Docket Item # 7
BAR CASE #2008-0181

BAR Meeting
November 5, 2008

ISSUE: Signage
APPLICANT: Tim Traywick
LOCATION: 821 South Washington Street
ZONE: CRMU/L, Commercial

Figure 1: Proposed signage

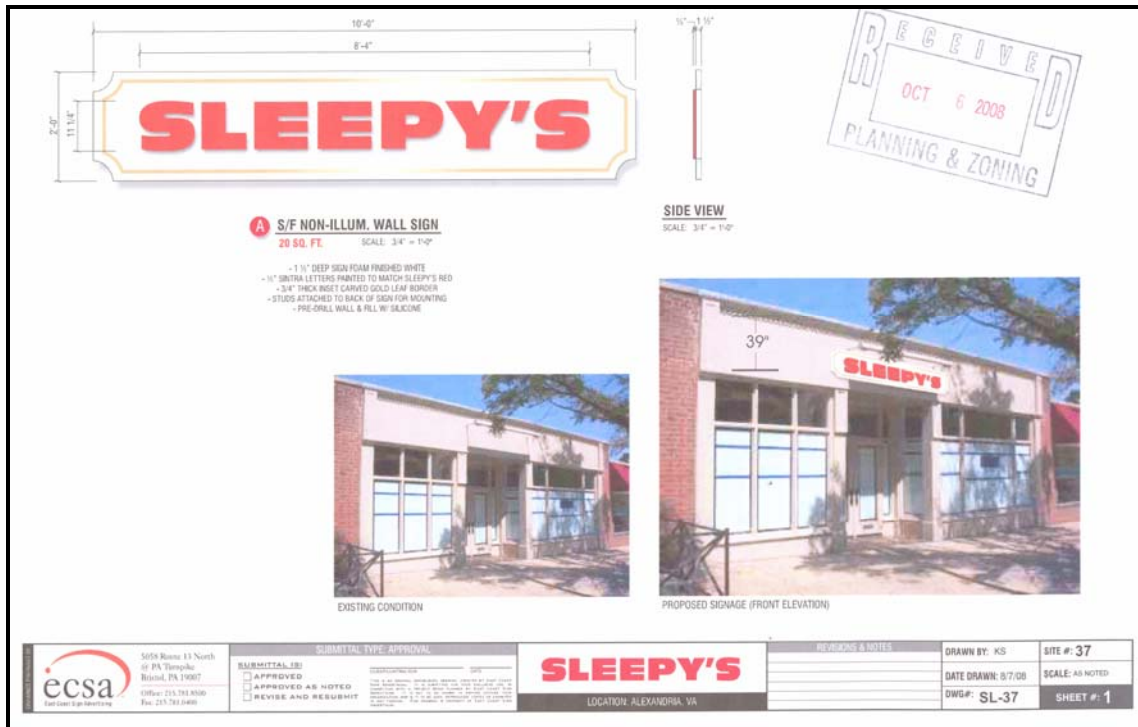
The applicant is requesting approval of a Certificate of Appropriateness for a sign, SLEEPY'S, at 821 South Washington Street. The individual red letters are proposed to be mounted on a 1 ½" deep white foam board with an inset gold leaf border. The sign will measure 10' by 2' and will be mounted above the entrance to the store. The sign will be illuminated by an existing light fixture.

The *Design Guidelines* generally recommend that buildings with multiple retail tenants have a sign plan with coordinated graphics. Although a coordinated sign program does not exist for this property, there is some consistency among the majority of the signs. With the exception of two signs, the businesses are identified by either individual letter pin mounted signs or signs painted on the molding above the entrance. In the opinion of Staff, the proposed sign should either be composed of individually mounted pin letters or painted on the storefront above the entrance, thus eliminating the foam backing board. Another reason to delete the foam board is that the BAR generally discourages the use of plastic material in the historic districts.

C-1 Wall letters / signs must comply with USBC [H103-H111] Please indicate the method to be used for anchoring the letters to the wall.

1. That the foam backing board be deleted; and,
2. That the sign consist of individual pin mounted or painted letters.
